Beachwood Planning and Zoning Commission Meeting Agenda – Amended
Tuesday, December 3, 2024, 6:30 PM
at Beachwood City Hall, Council Chambers,
25325 Fairmount Boulevard, Beachwood, Ohio 44122

MEMORANDUM
CITY OF BEACHWOOD
PLANNING AND ZONING COMMISSION MEETING

P & Z 2023-17 Applicant has requested preliminary site plan approval for residential development of cluster homes to be located at PPN 741-29-020 North Woodland Road (Fairmount Blvd.)

SITE PLAN -
PROPOSED

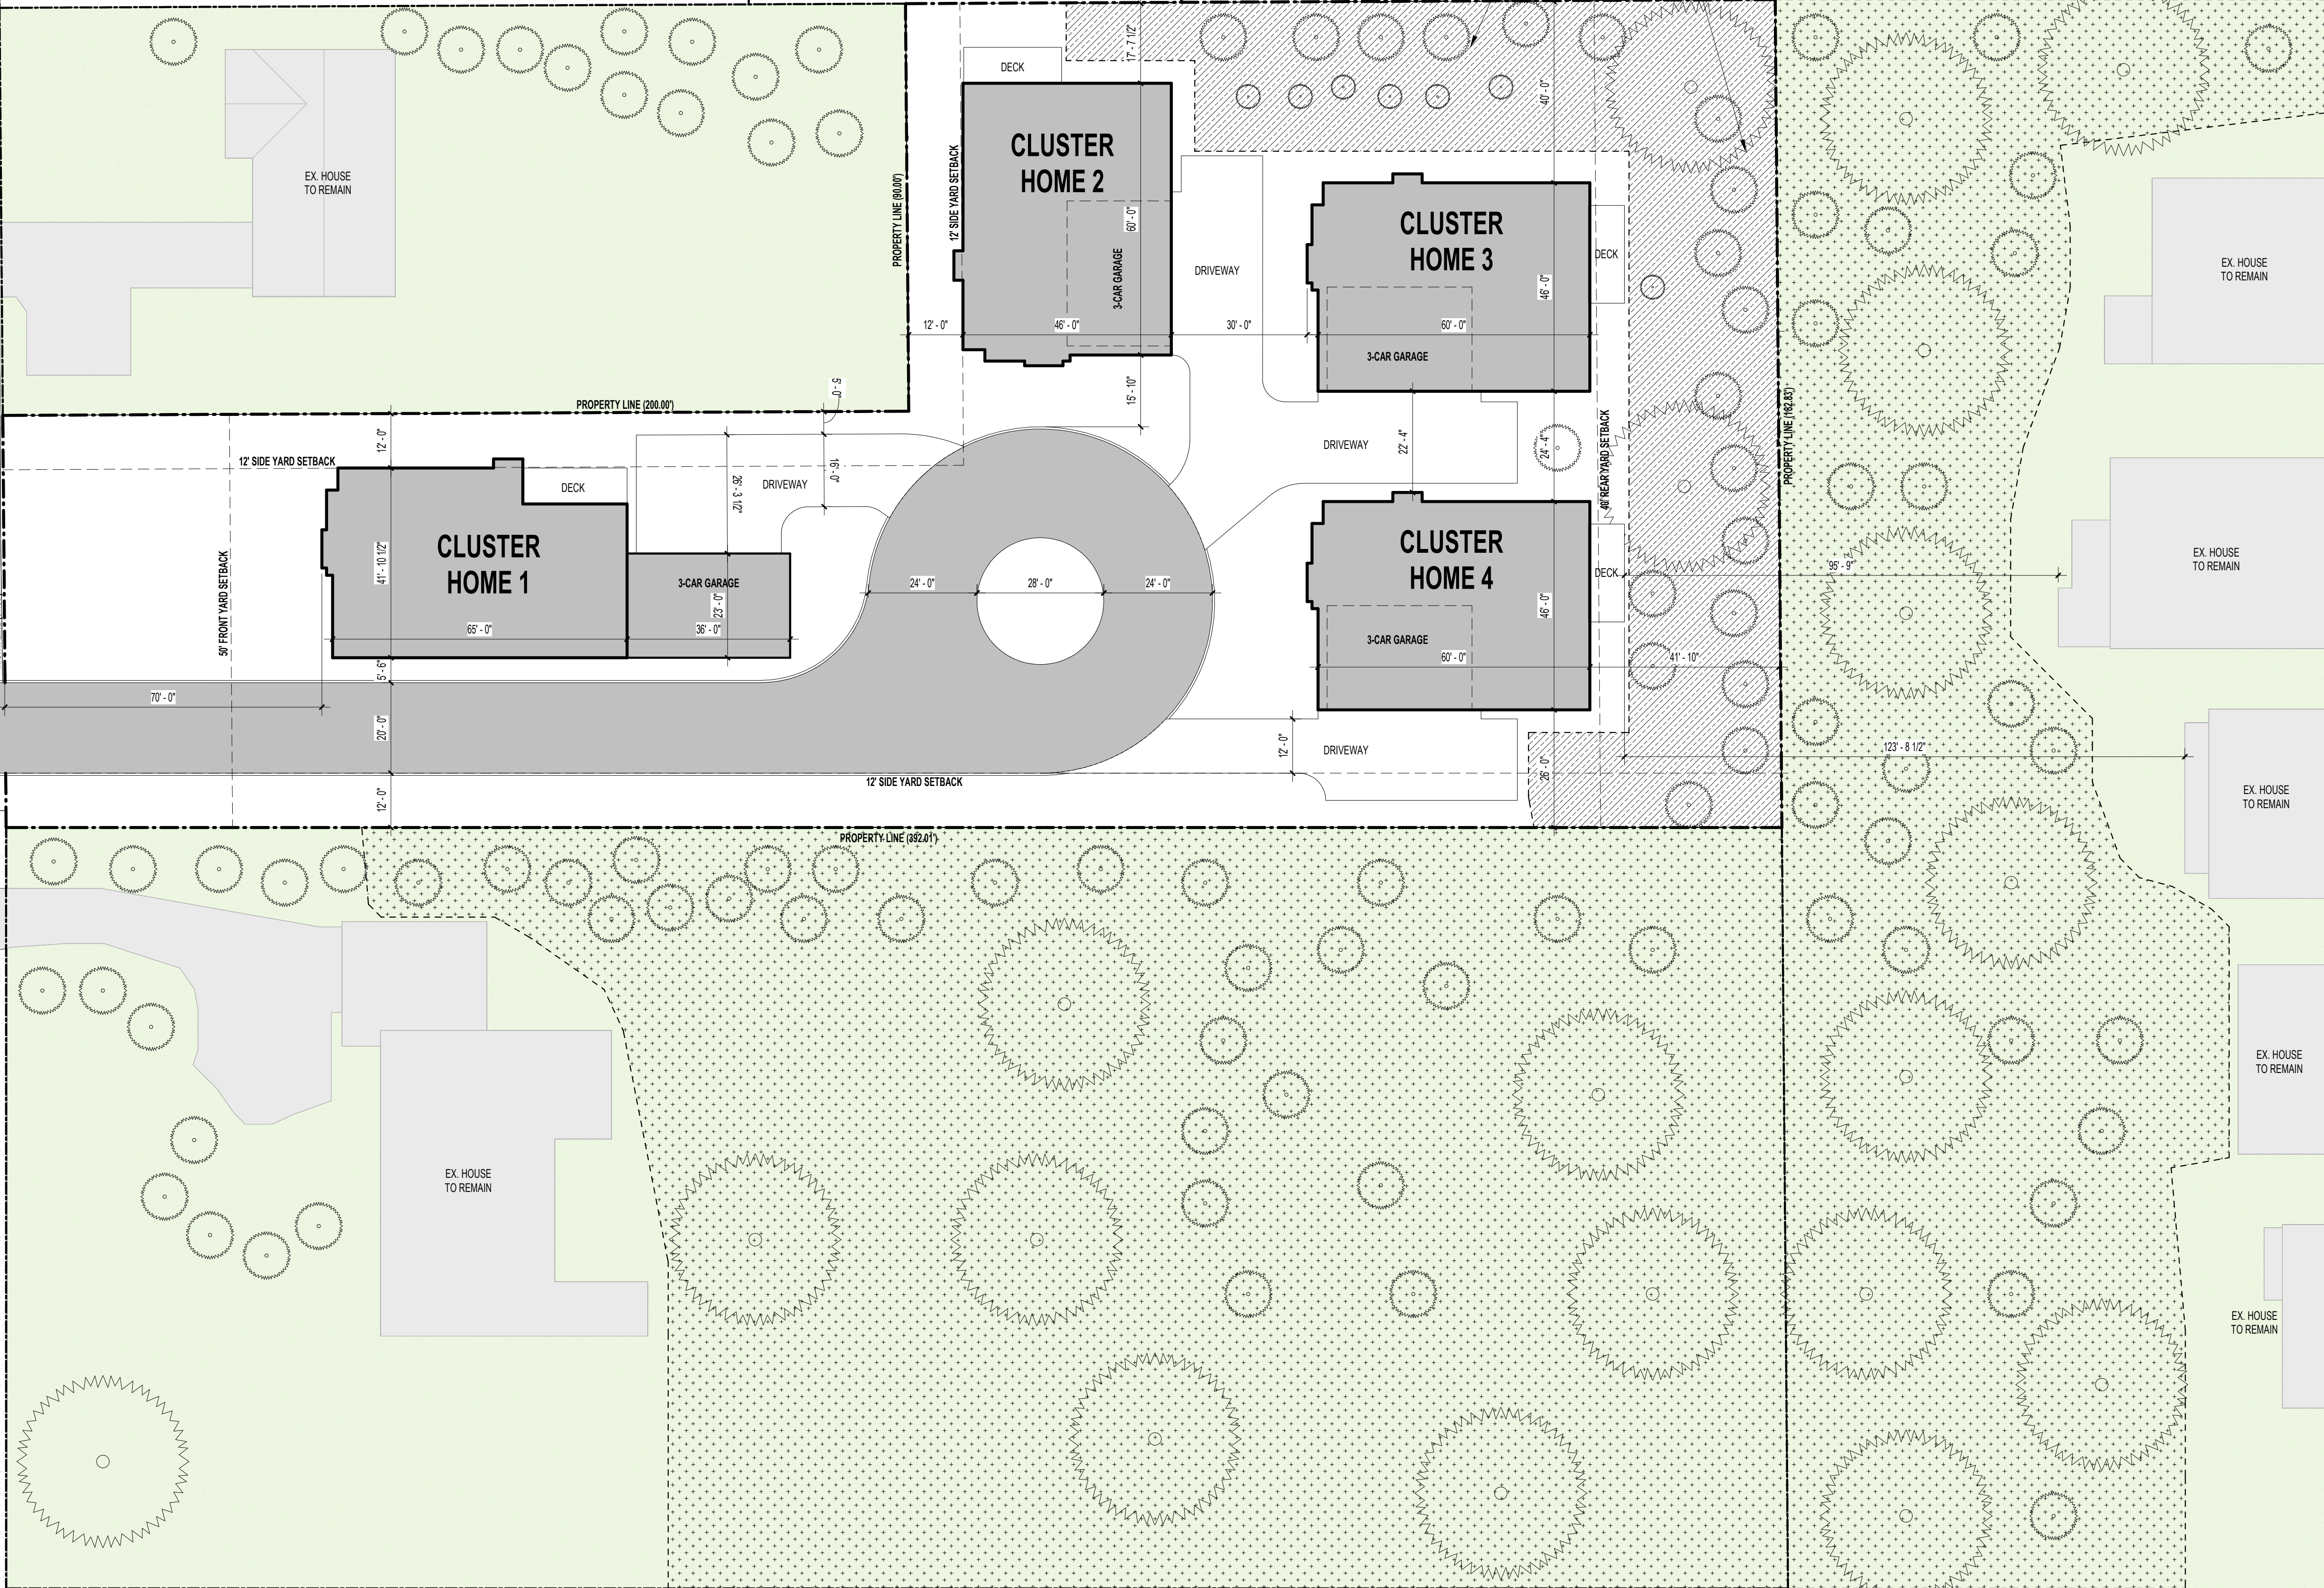
We cannot recommend approval of a preliminary site plan until we have more information concerning the wetlands, which are showed squared off behind the units. The US Army Corps must approve any and all modifications to designated wetlands.

Cul-De-Sac Area should provide enough area for purpose of turn-around of Emergency Vehicles:

RE: **P&Z 2024-44** **Bialosky**
Fuchs Mizrachi School
26600 Shaker Boulevard
Preliminary Site Development Plan

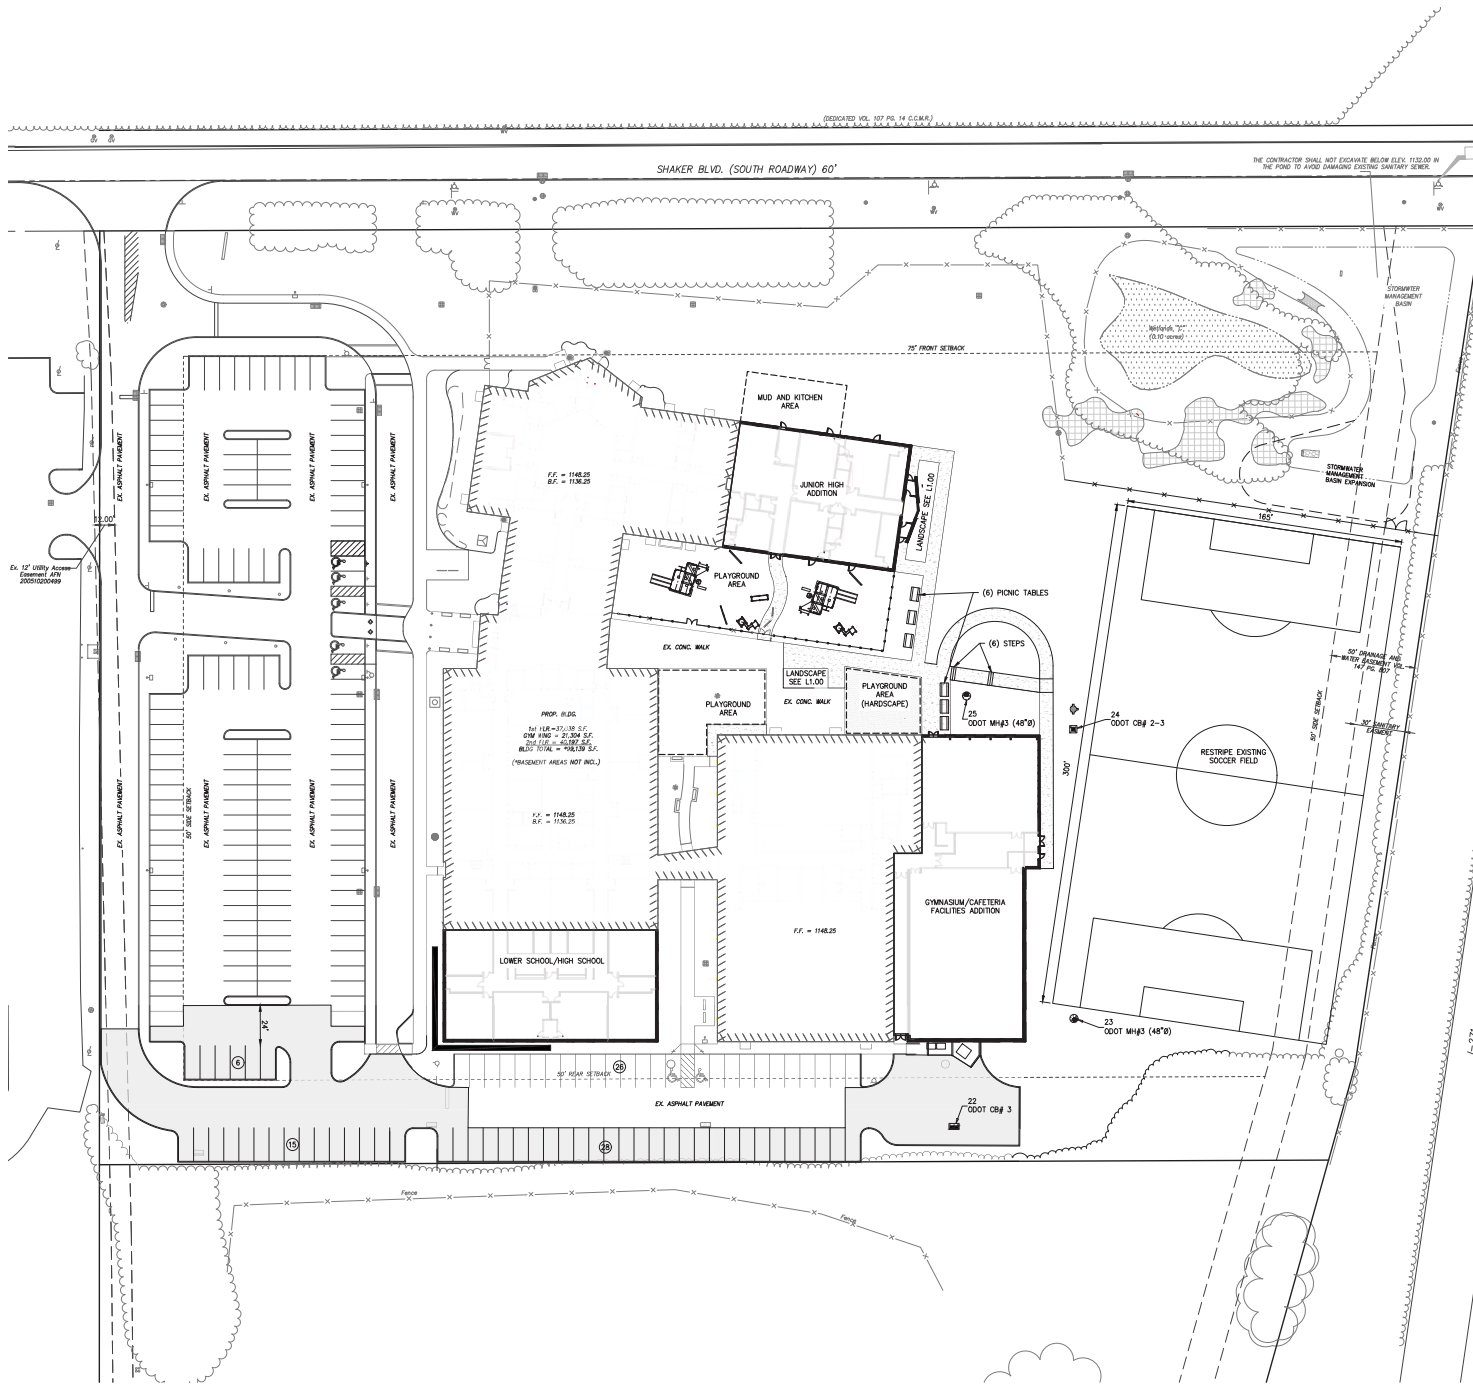
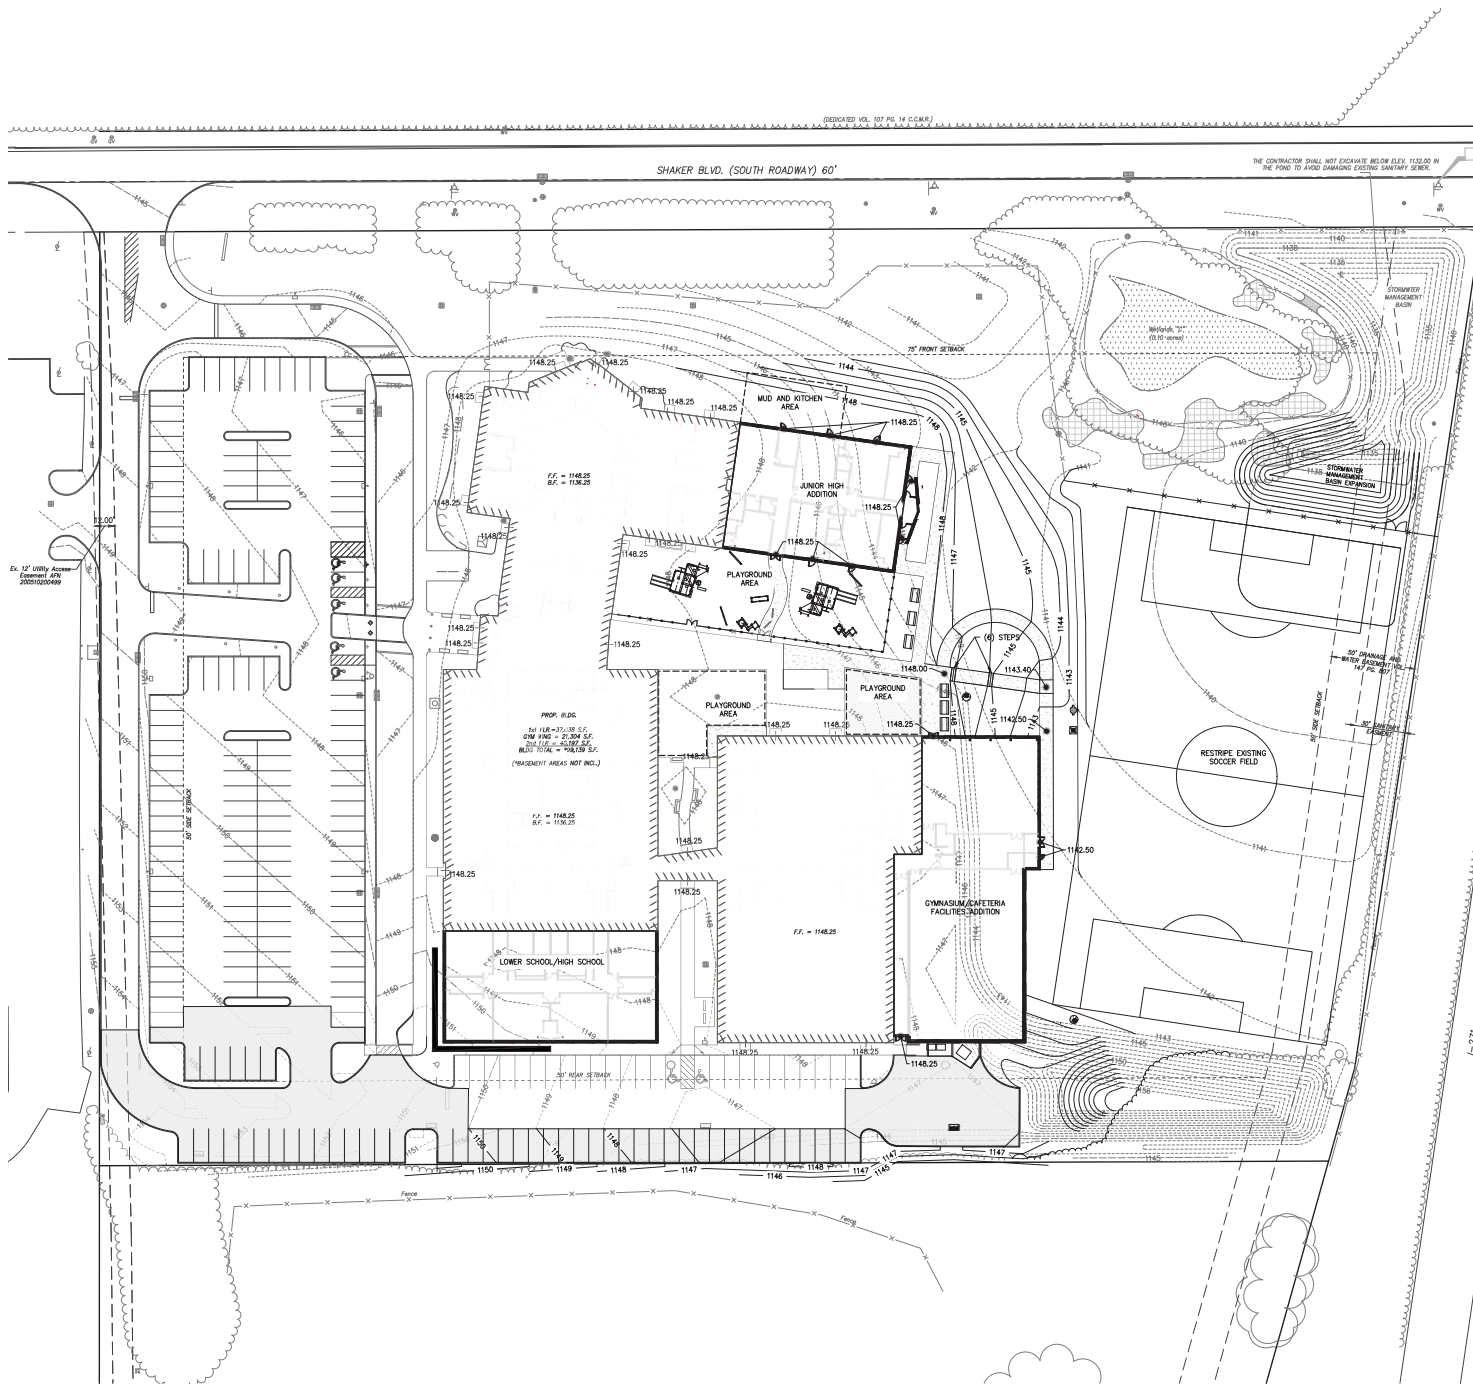
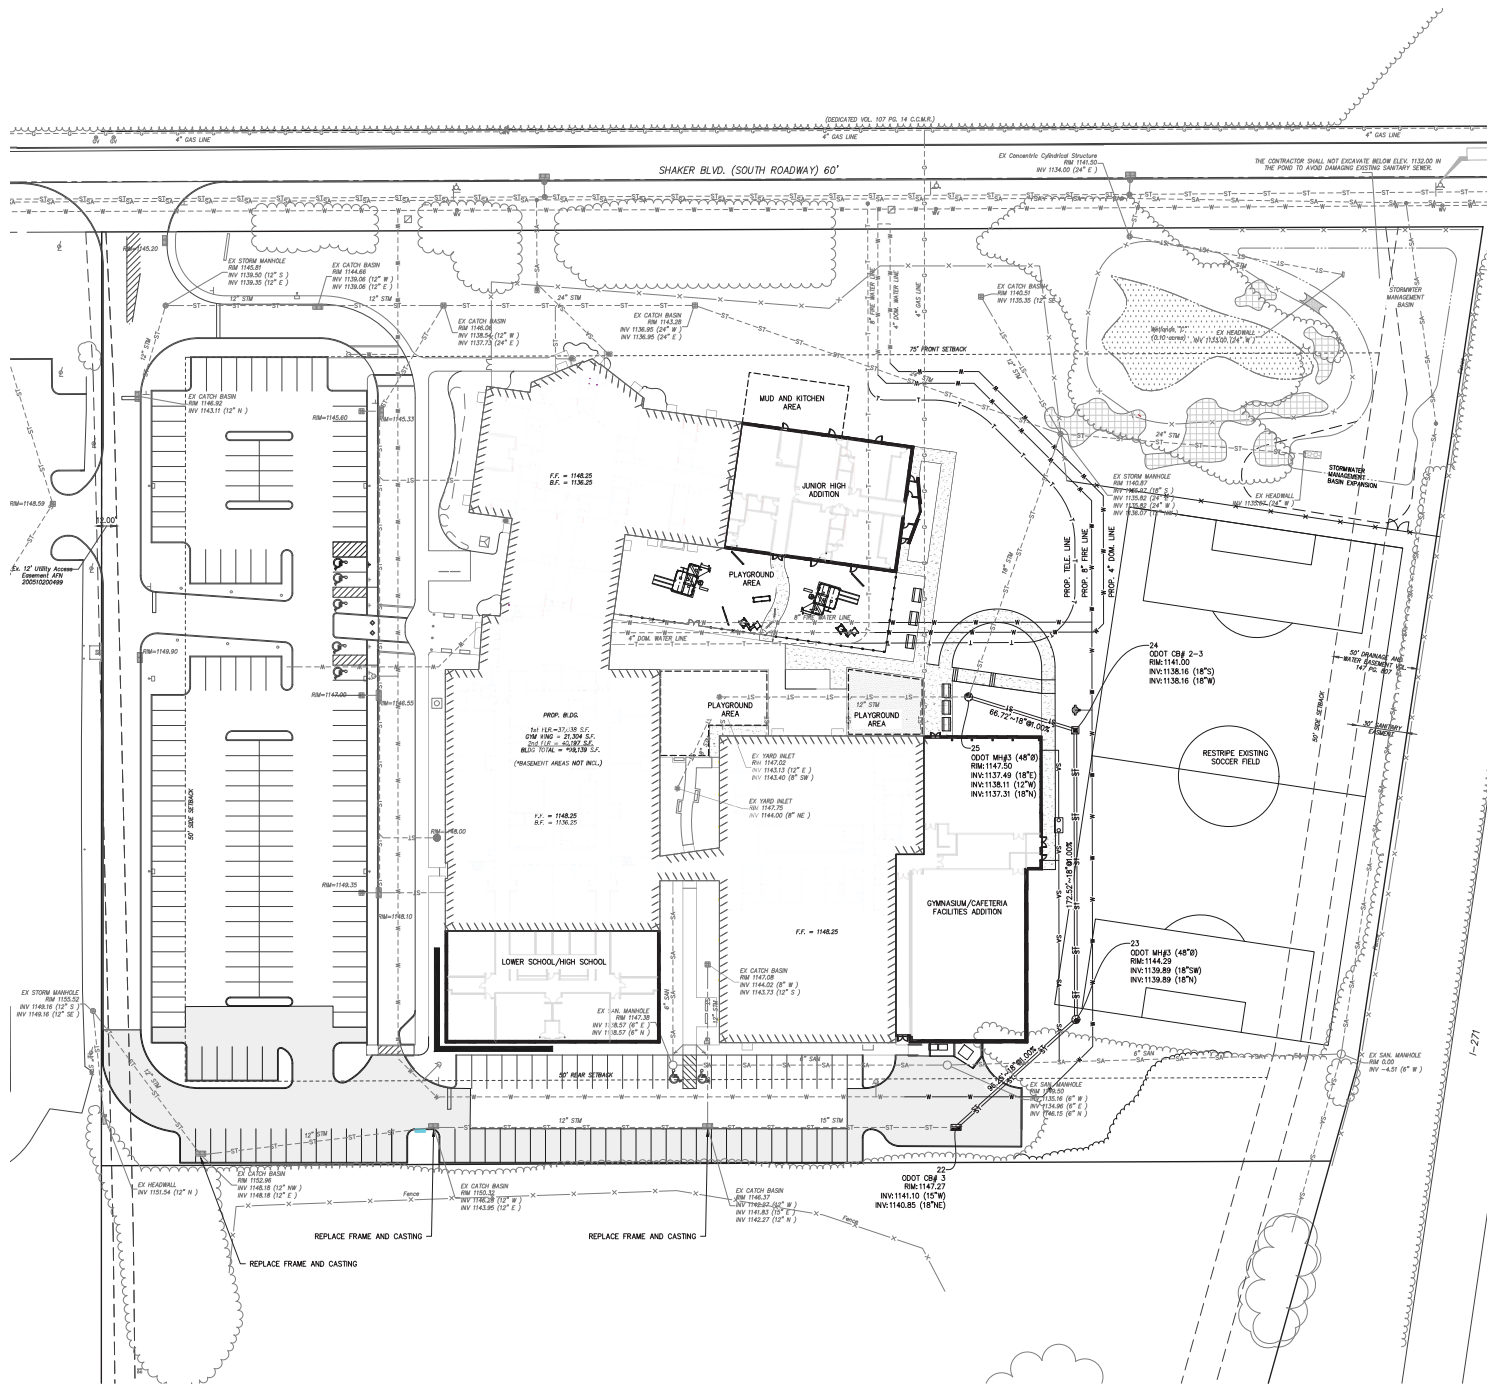
This request is for preliminary site development plan approval for the expansion of the existing school. The subject site is in the U-5 Public and Institutional District. The applicant is proposing to construct three (3) additions to the existing building. The northern addition is a two-story classroom addition with 8,168 square feet per floor. The southern addition is also a two-story classroom addition that consists of 8,533 square feet per floor. The eastern addition is a high one-story addition to the gymnasium and cafeteria. This addition is 13,969 square feet and includes a partial mezzanine. The proposed expansion will increase the total number of classrooms to 39 and increase the capacity of the school to approximately 900 students. The proposed building additions as proposed will meet all of the building setback requirements of the U-5 Public and Institutional District. The applicant has provided preliminary building elevations and a building massing plan for the additions. The intent is to match the architectural style and materials of the existing building.

The site plan indicates installation of the previously approved land banked parking spaces along the southern property line. The 49 additional parking spaces to be installed will bring the total number of improved parking spaces on the site to 210. That number of parking spaces is compliant with the minimum Zoning Code requirement. The applicant has provided preliminary site lighting and landscaping plans that conform to City standards and are consistent with the originally approved site development plan. The applicant has also provided preliminary site grading and storm water management plans.

1. Geometric plans
2. Utility plans
3. Grading plans
4. Stormwater Management plans (for both during construction and post construction).
5. Drainage calculations to support the Stormwater Plan.
6. Pavement composition plans.

It is recommended that the Commission grant preliminary site development plan approval.
